**Minutes: Meeting with residents along Lawson Drive Barooga to discuss proposed half cost scheme footpath from Buchanans Road to Hay Street Date: 01/12/16 Time :1600hrs**

PROJECT TITLE:  
**Lawson Drive Footpath**  
 \_\_\_\_\_  
 \_\_\_\_\_  
 DRAWING DESCRIPTION:  
**GENERAL LAYOUT - SHEET 01**

PROJECT TITLE:  
**FOOTPATH & ROAD SLOW POINTS  
 CONSTRUCTION FROM HAY STREET  
 TO BUCHANANS STREET**

DRAWING DESCRIPTION:  
**TREE REMOVAL PROPOSAL  
 PLAN VIEW  
 GENERAL LAYOUT - SHEET 01**

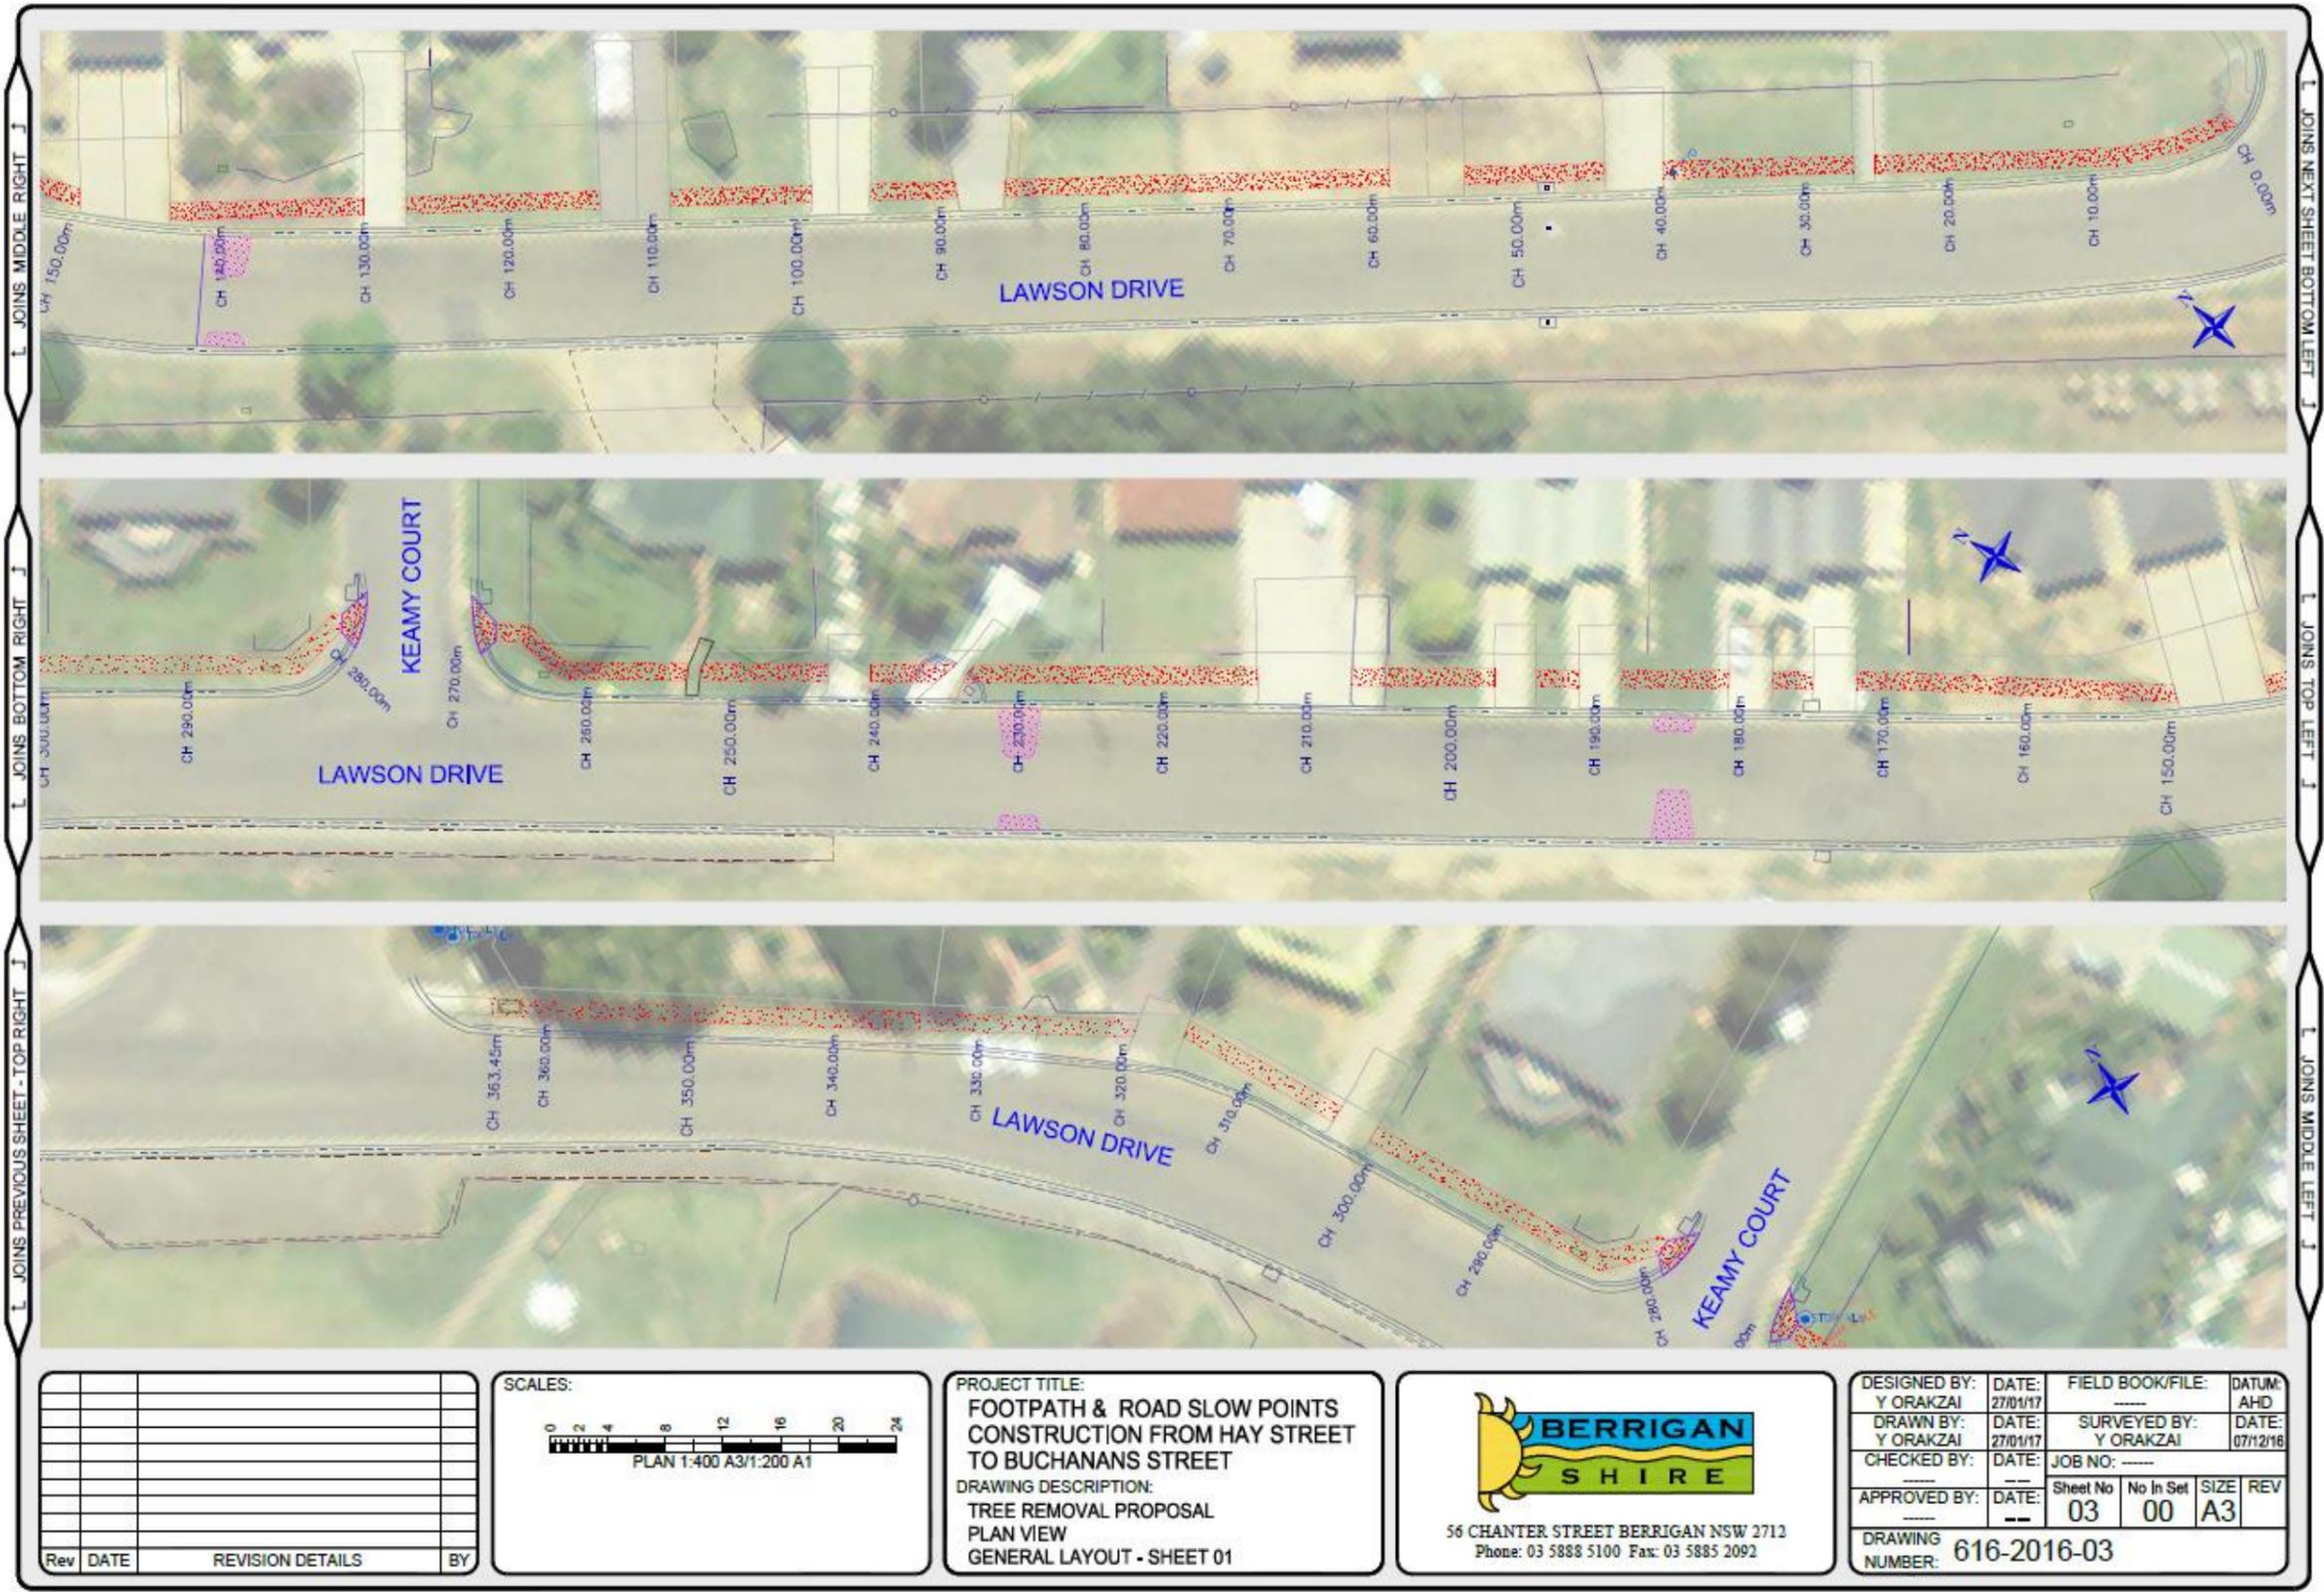
All of the Property owners that attended the meeting were not in favour of the alignment of the proposed half cost scheme. However, the majority were in favour of a footpath overall but for it to be on the south side of Lawson Drive for its entire length.

The residents indicated that they were opposed to proposed alignment due to the need for pedestrians to cross the road at what the majority considered a bad place.

The residents requested that a topographical survey be carried out on all of the crests on Lawson Drive be tested for head on collisions and safe sight stopping distances.

One resident requested reasons for putting it on the north side as opposed to the south side as it is necessary to cross the road regardless. The resident also requested a traffic island be considered if the footpath were to be put the north side.

The majority of the residents indicated that a crossing would be ideally located at the intersection of Buchanans Road and Lawson Drive.
